Proposed ground floor rear extension, loft conversion with rear dormer, floor plan redesign and all associated works at 10 The Coppice

Planning Drawings

Proposed Floor Plan

DRAWING NO. B75855 - 3100 A

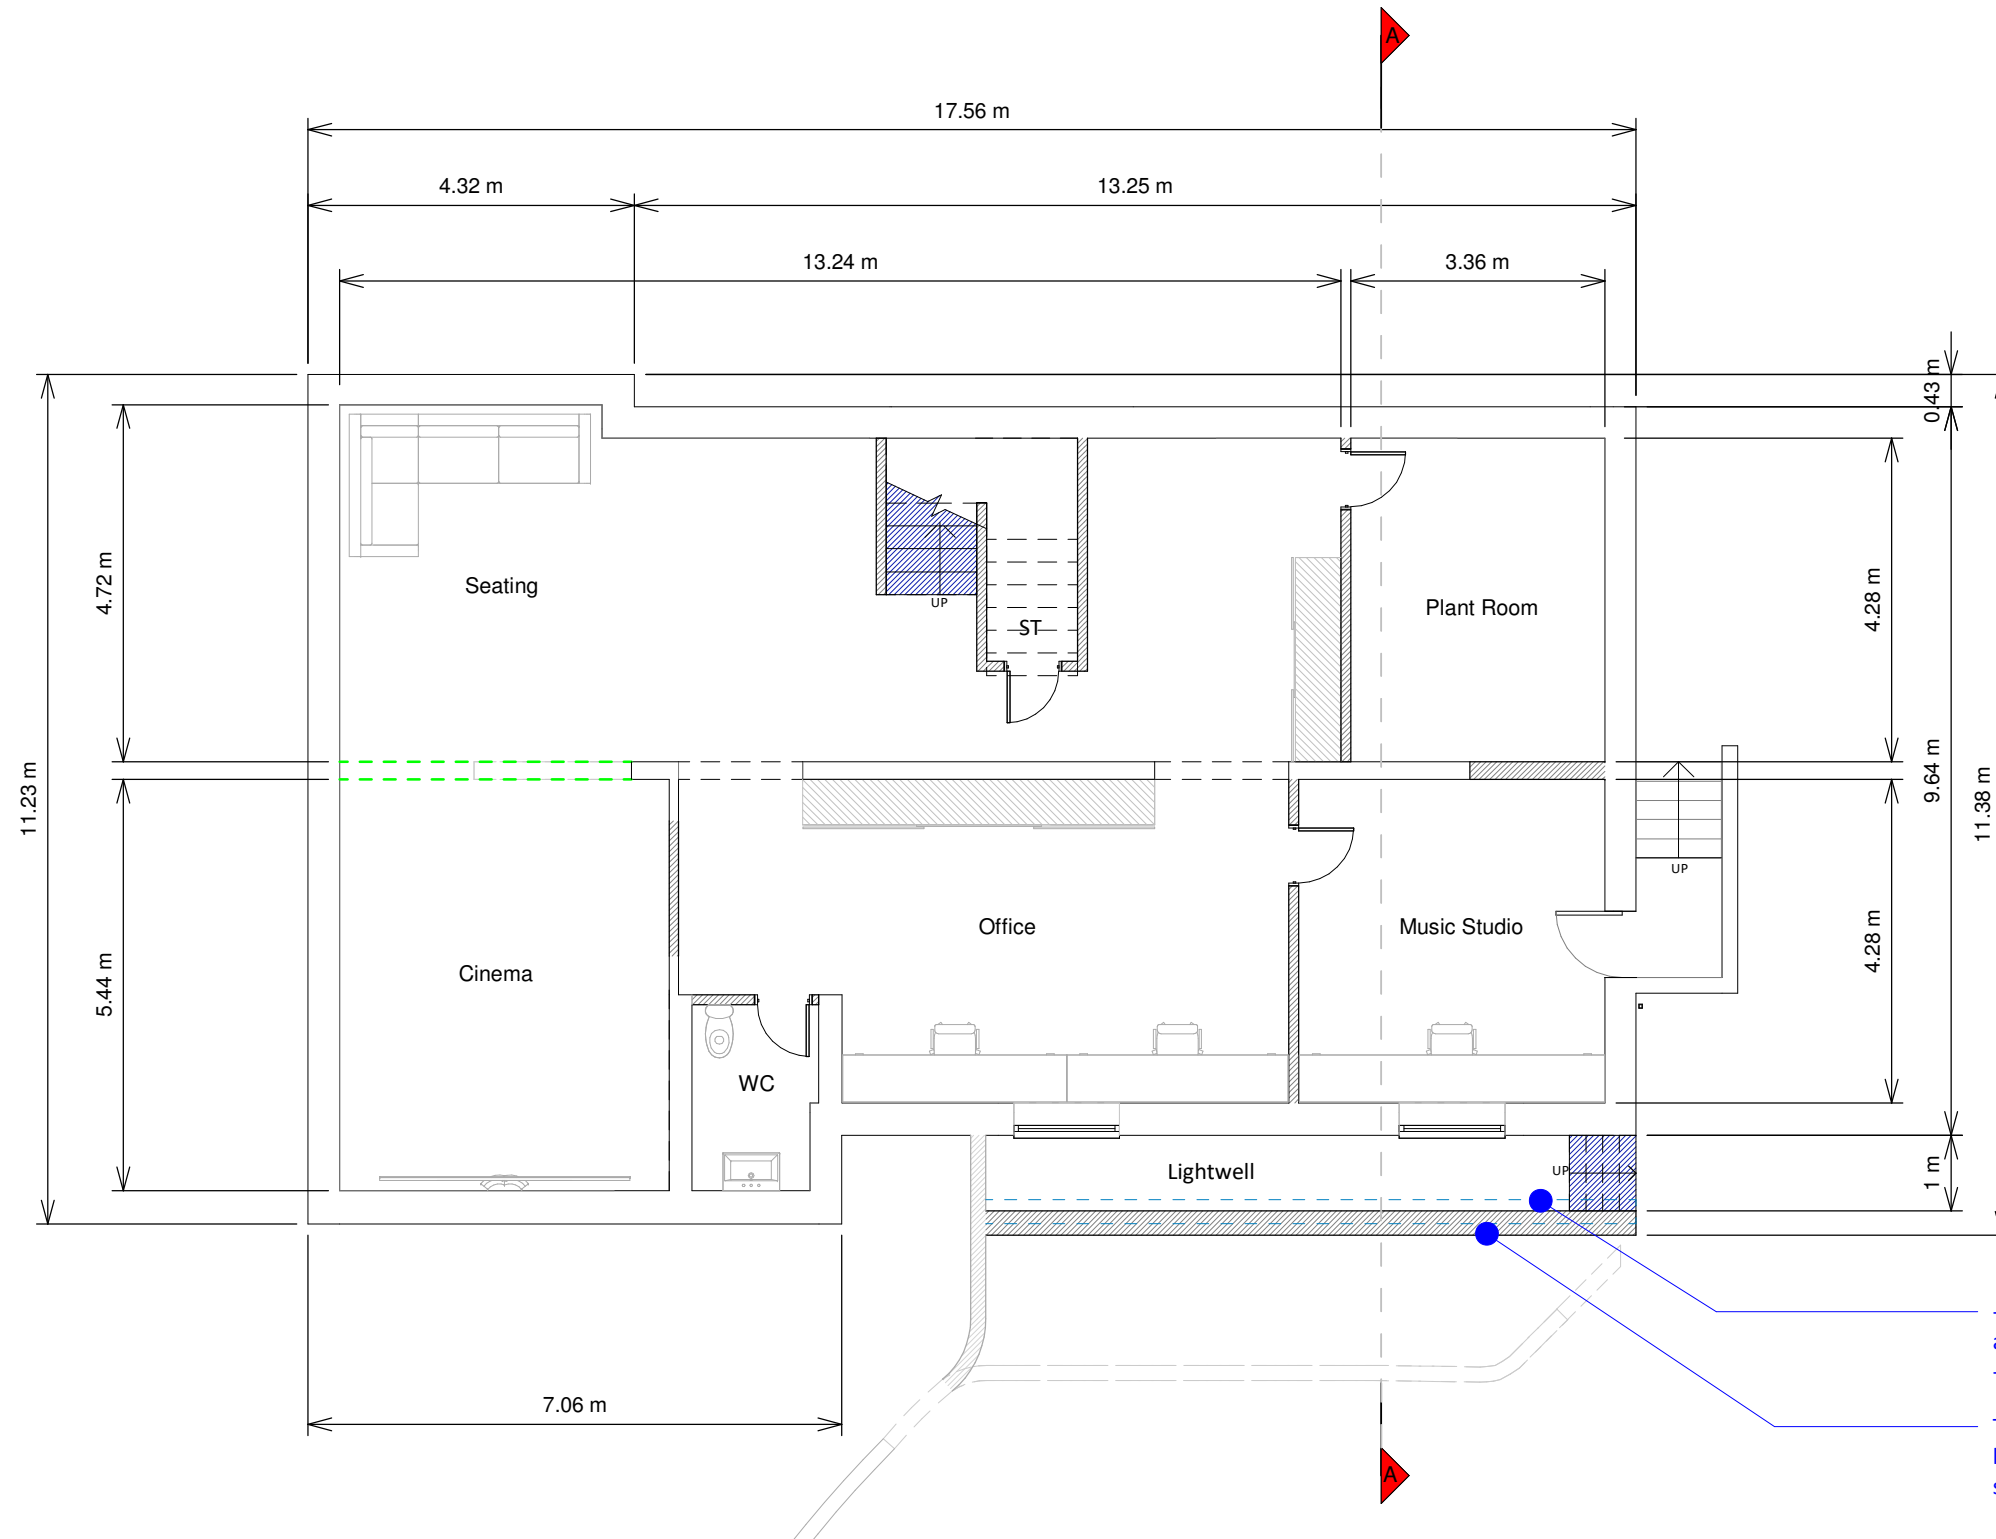
- Proposed elements for the resubmission;
- increase lightwell depth from 0.85m to 1m
- change window and door frames to aluminium painted grey
- increase rear extension from 4m to 6m

This application looks to increase the lightwell from 0.85m to 1m and add stairs and glass railing
